**COVER LETTER FOR  
THE UP DATING OF THE ORIGINAL REPORT: MARCH 27, 2024  
WITH OPTIONS: FOR FULL BAY REPLACEMENTS OR  
PARTIAL BAY REPLACEMENTS  
AUGUST 7, 2025**

**AIR CITY GARAGE  
27 S. JEFFERSON STREET  
DAYTON, OH 45402**

**Add August 6, 2025 for Pricing**

Project No.24.200.020

FOURTH to FIFTH SURFACE w/ SOFFIT OVERLAID PARTIAL FLOOR SHOWN

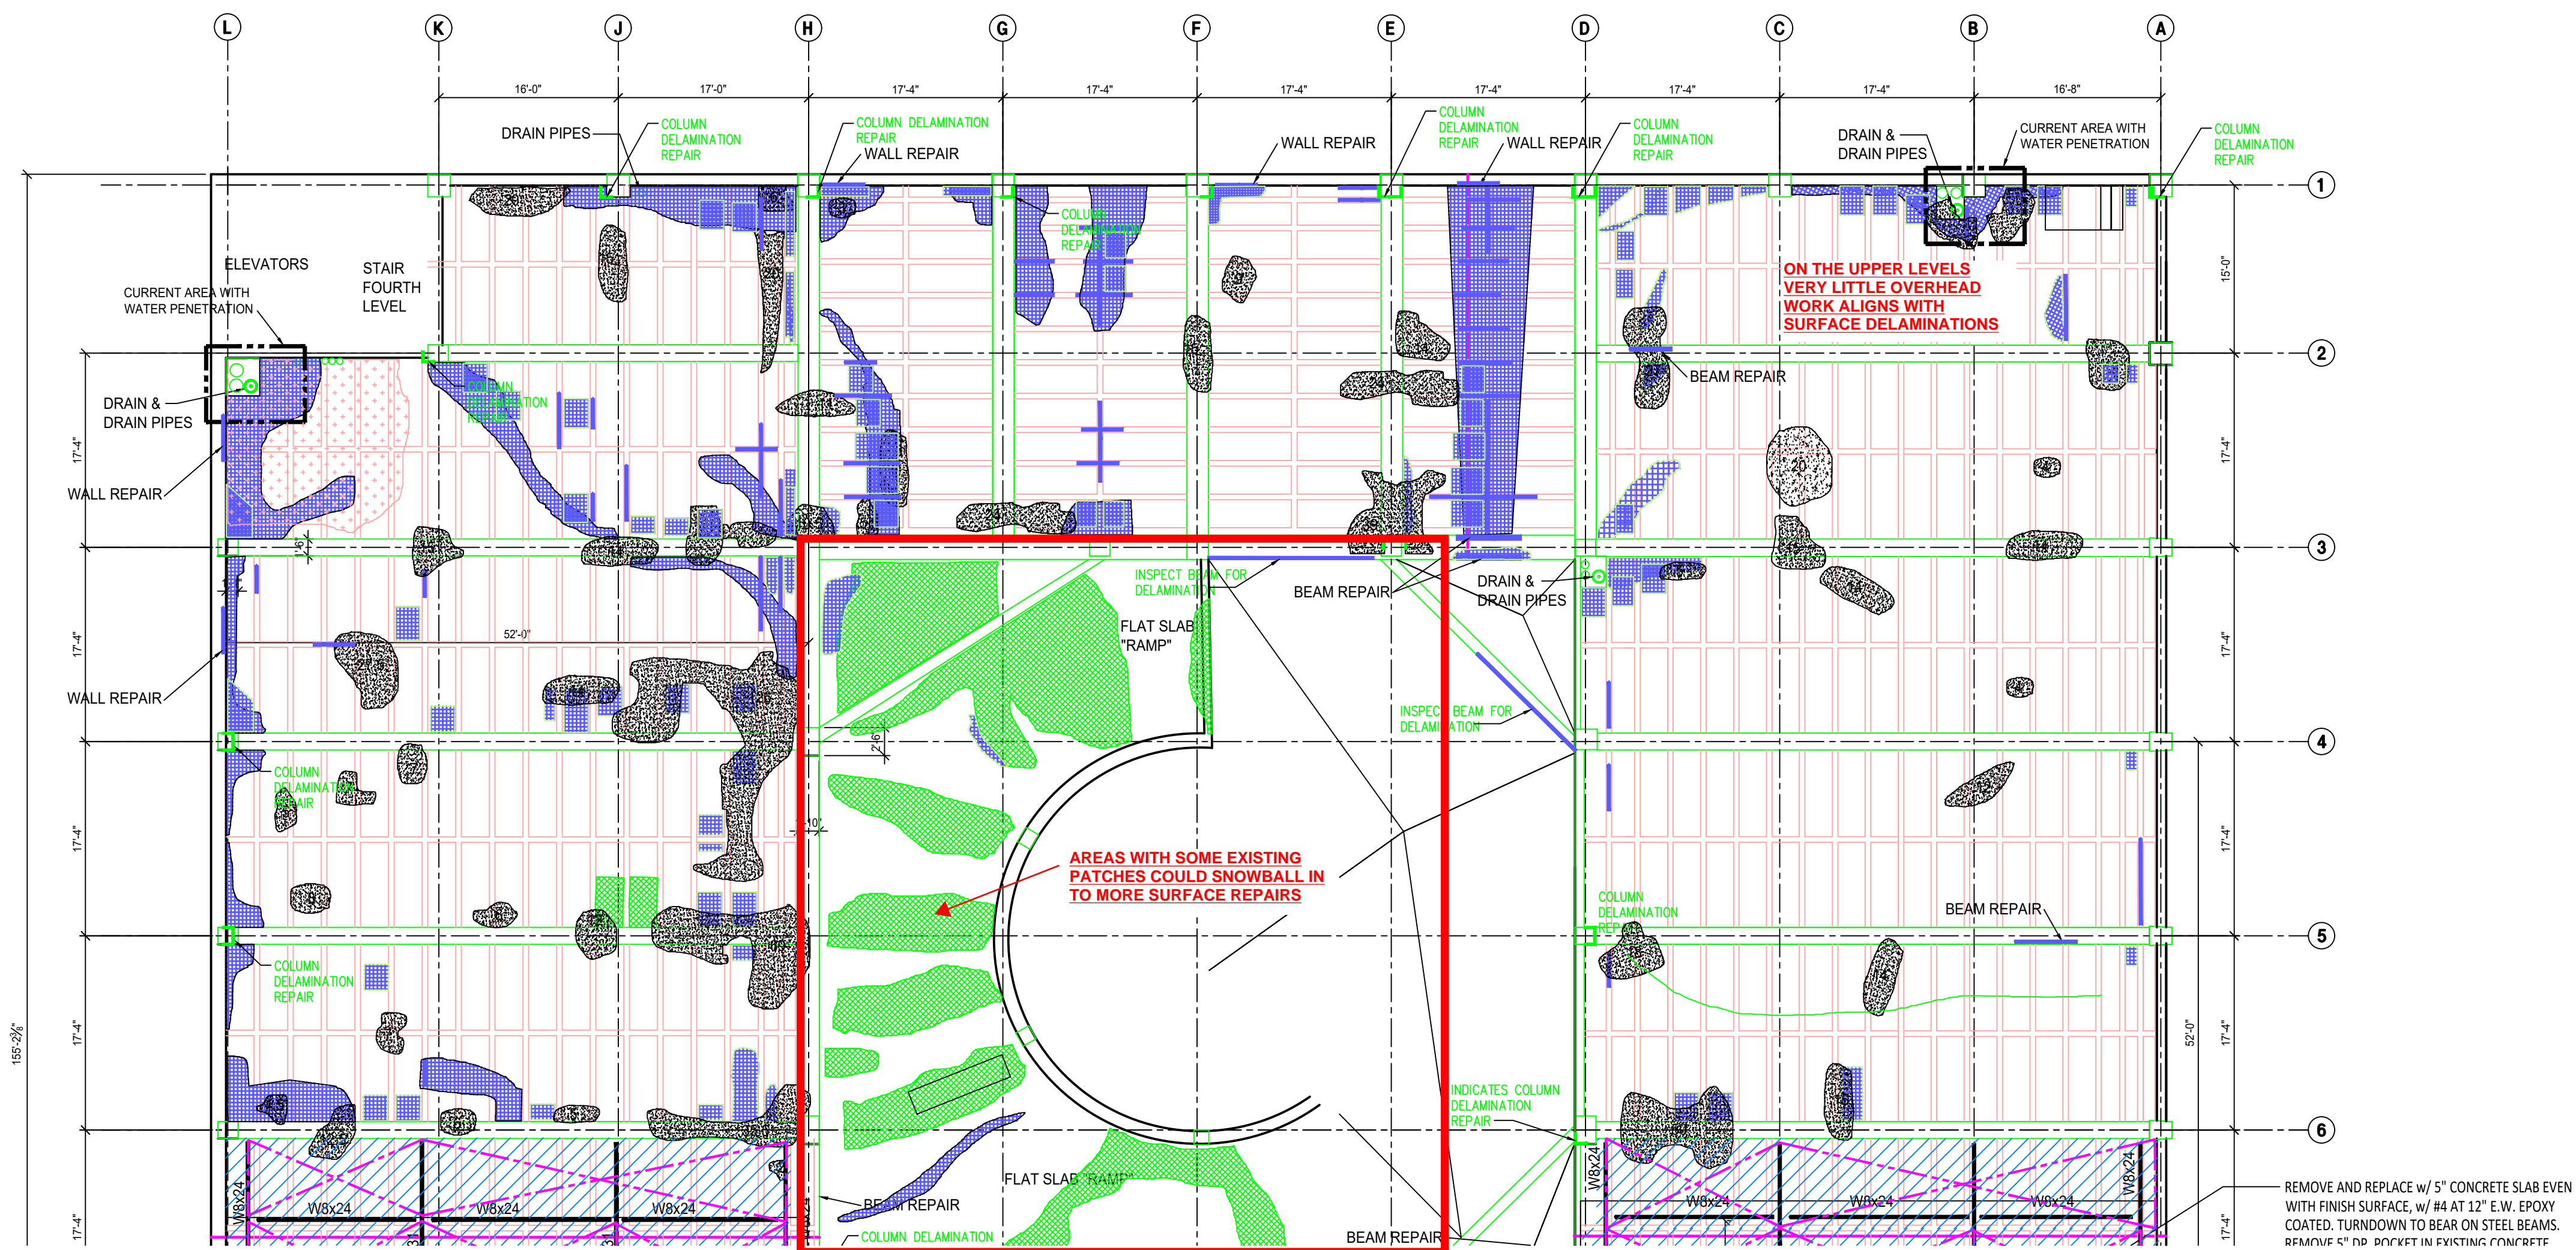
**TOTALS DEDUCTING OVERLAPING REPARES SURFACE VS SOFIT**  
**& SUBTRACTING for REPLACING 13 BAYS w/ NEW 6" SLAB,**  
**so 13 BAYS WITH 6" SLAB, NEEDS TO BE ADDED in .**

The numbers I came up with for the revised quantities for removing some bays are,  
Delaminated Concrete on the Surface Originally was 11,315, the number to Subtract if 6” concrete slabs are used is 8941 with 1161 sq.ft. overlapping. Leaving a final total of 7780 sq.ft. if the 13 locations use a 6” concrete slab replacement.

For the Rib Repair I started originally with 3406 lin.ft. Subtracting 751 lin.ft. Leaving a final total of 2655 lin. Ft.. If the 13 locations use a 6” concrete slab replacement.

For the Soffit Pans I started with 8179 sq.ft. Subtracting 2697 sq.ft.. Leaving a final total of 5482 sq.ft.. If the 13 locations use a 6” concrete slab replacement.

RAISED STEEL BEAMS AT EXISTING CONCRETE BEAMS

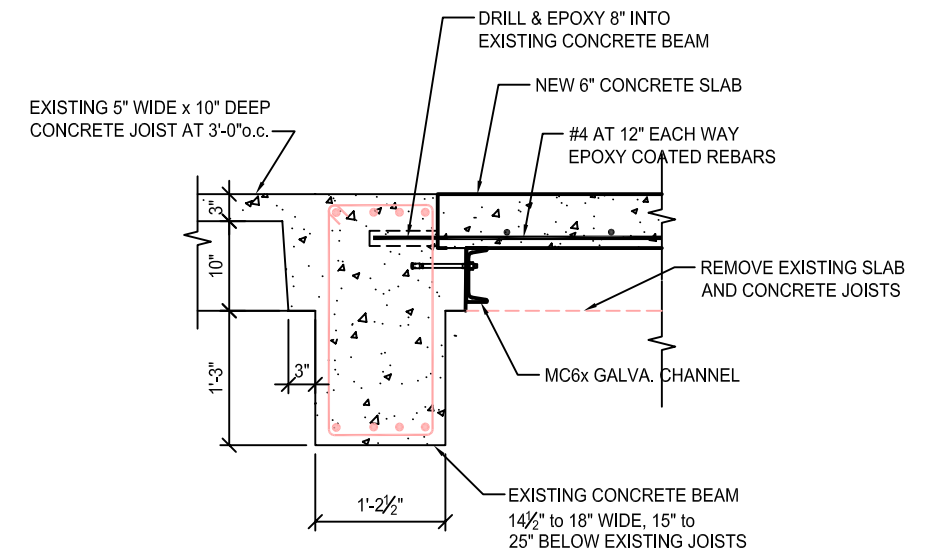
DO NOT CUT THRU ANY BEAM REINFORCING STEEL

**CONNECTIONS WILL BE DESIGNED UNDER ENGINEERING SERVICES ONCE A PATH IS SELECTED**

EXISTING PARKING GARAGE  
SECOND TO FIRST LEVEL SURFACE

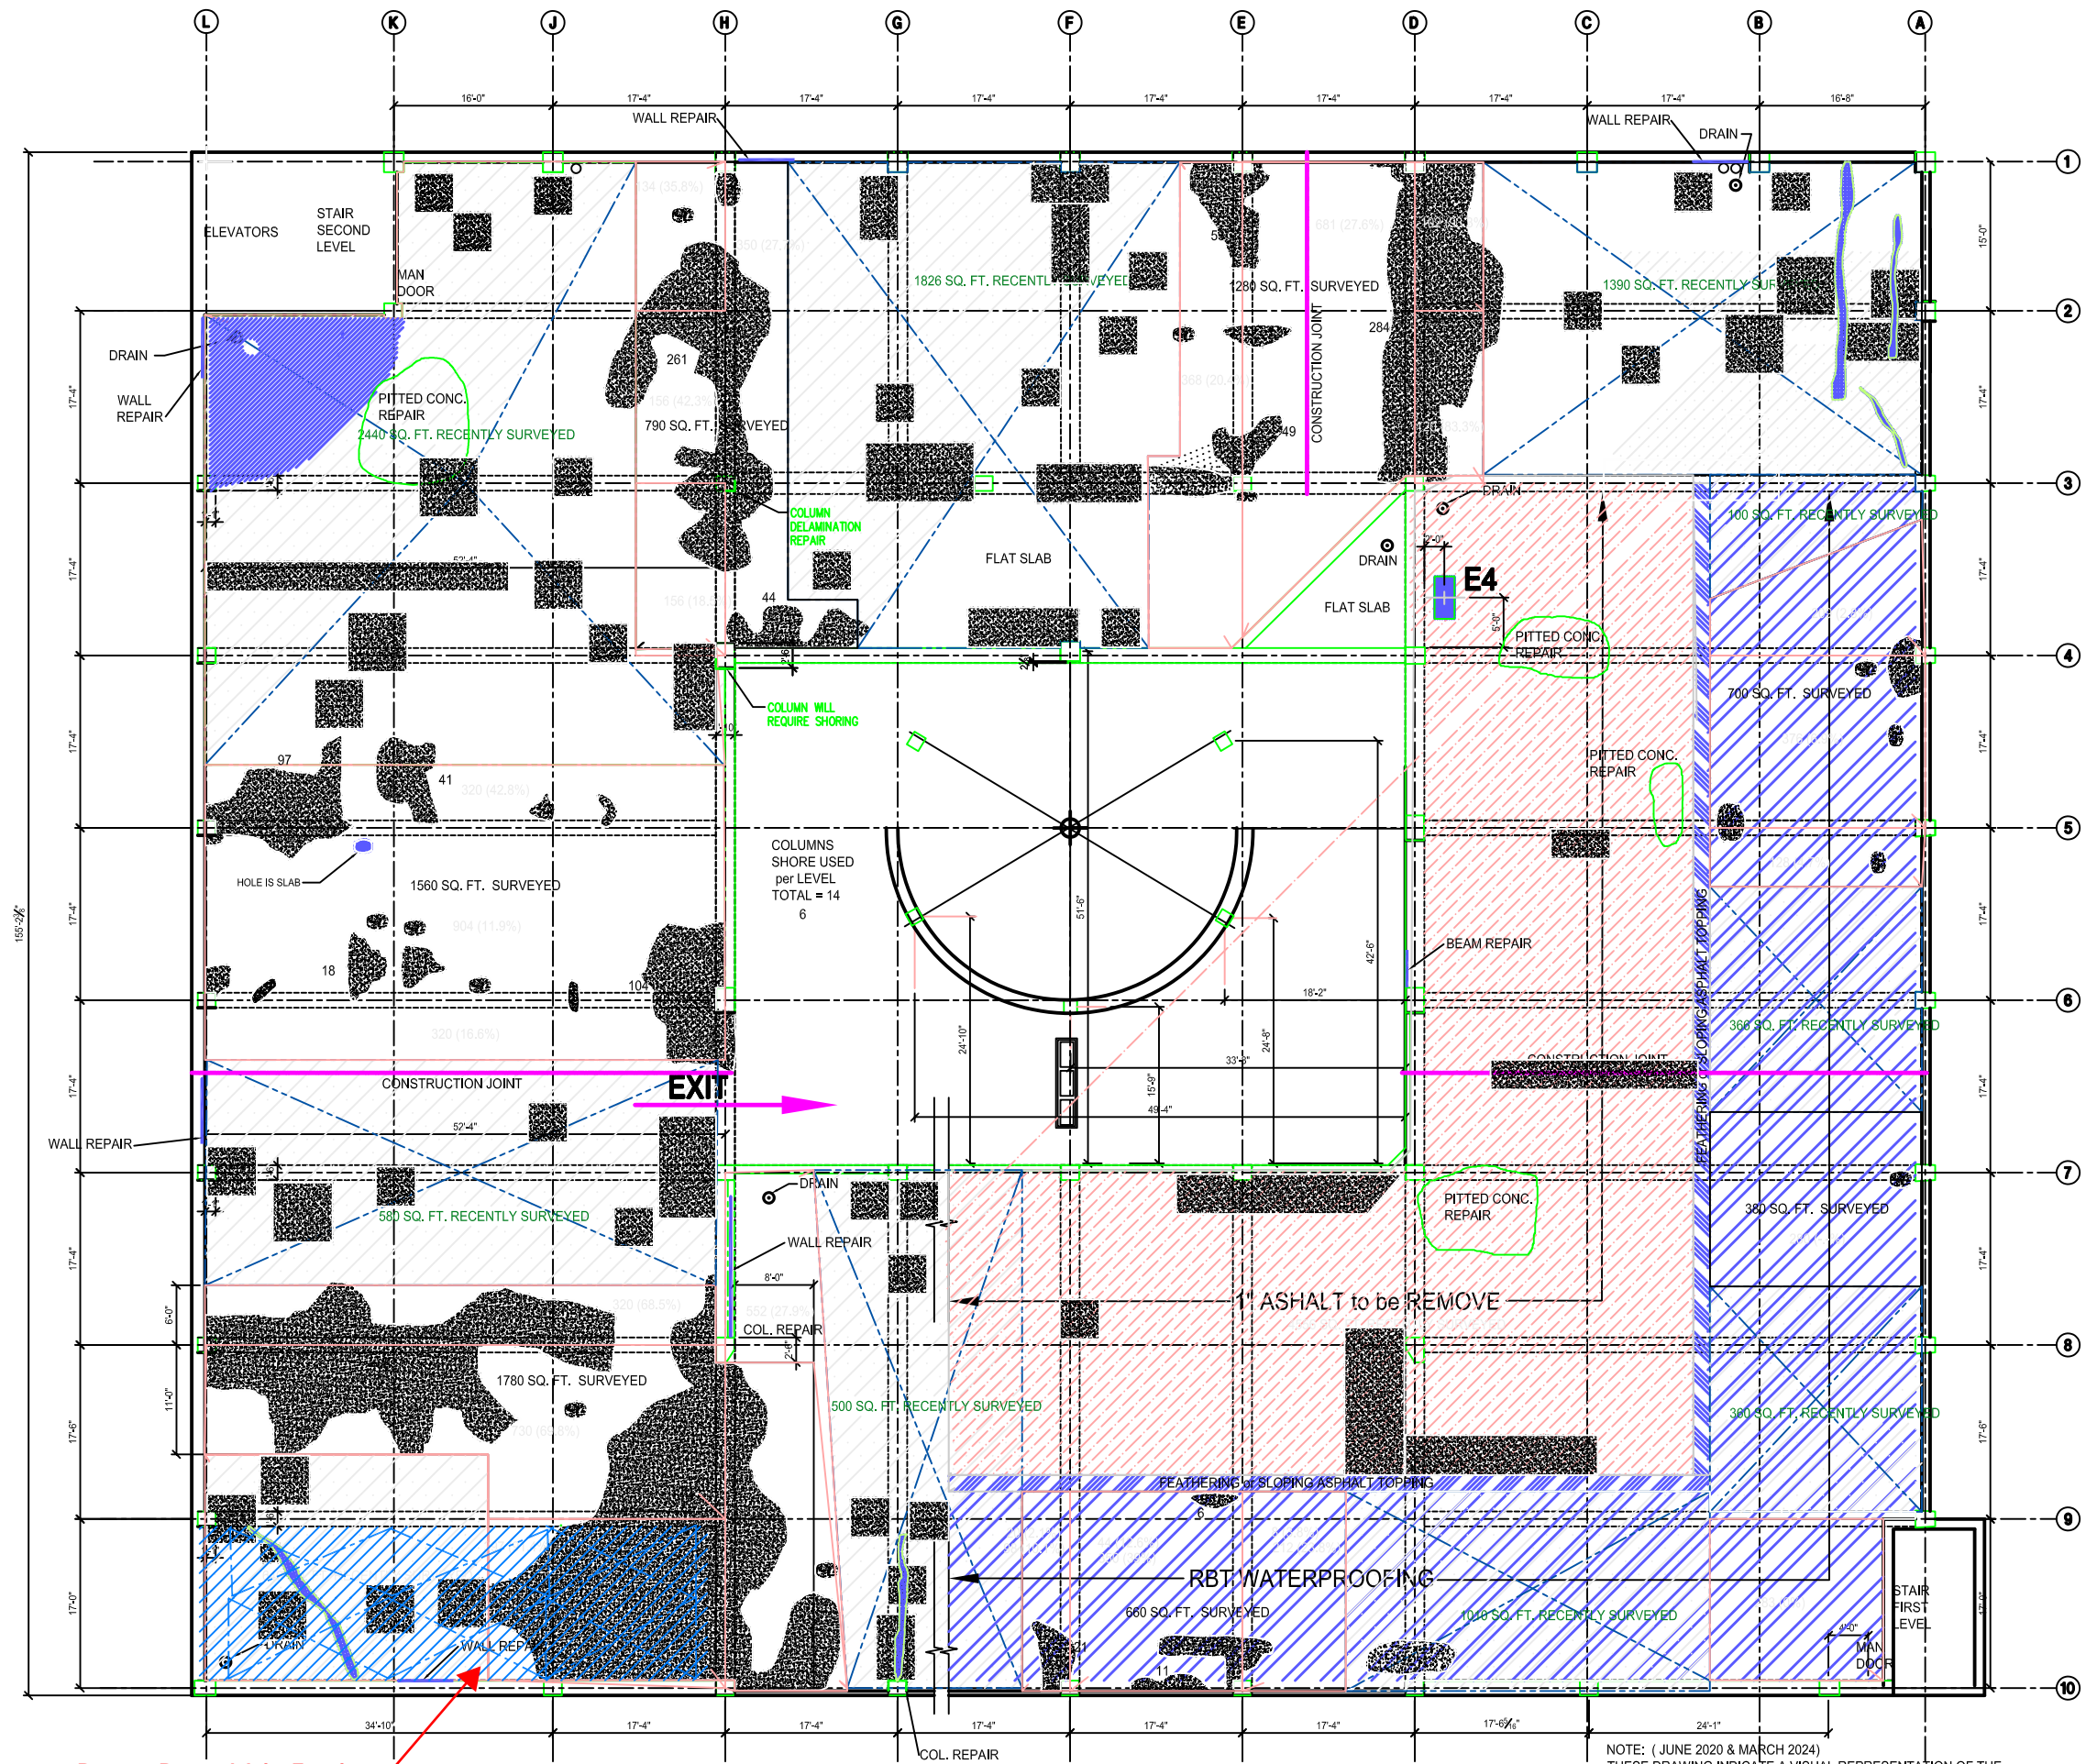
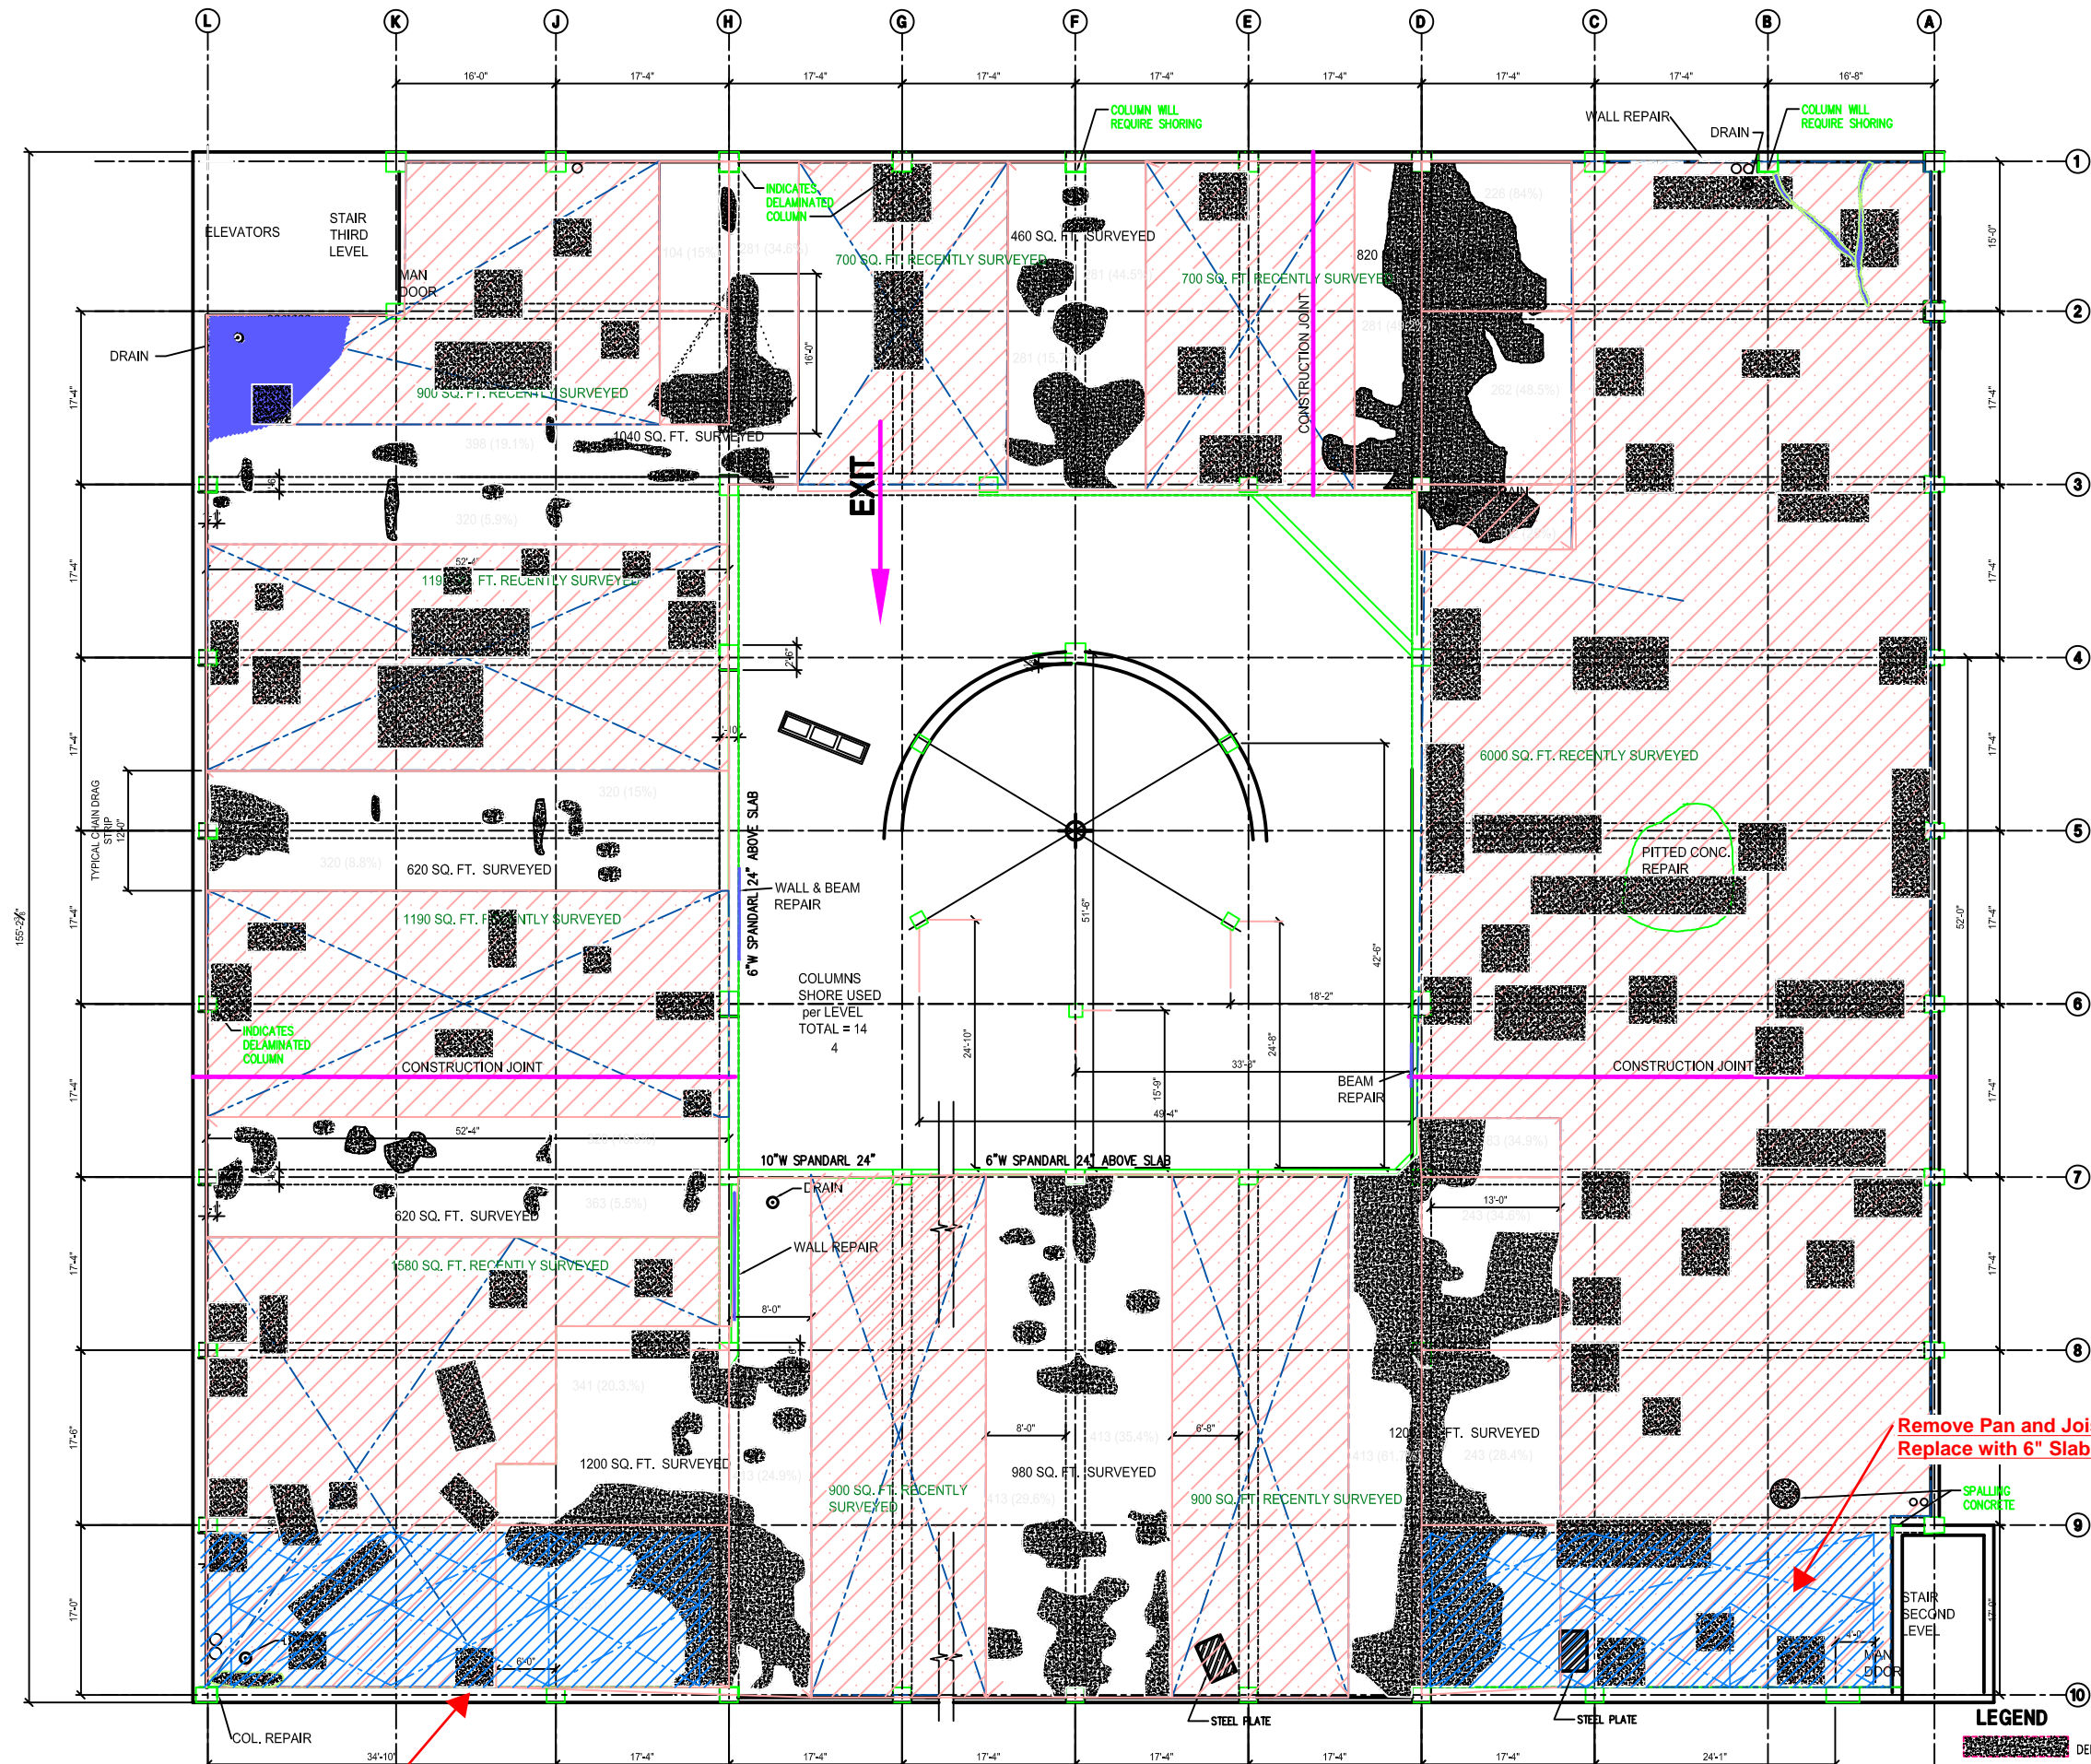
Remove Pan and Joist Framing  
Replace with 6" Slab & Steel Beams

**Remove Pan and Joist Framing  
Replace with 6" Slab & Steel Beams**

**Remove Pan and Joist Framing  
Replace with 6" Slab & Steel Beams**
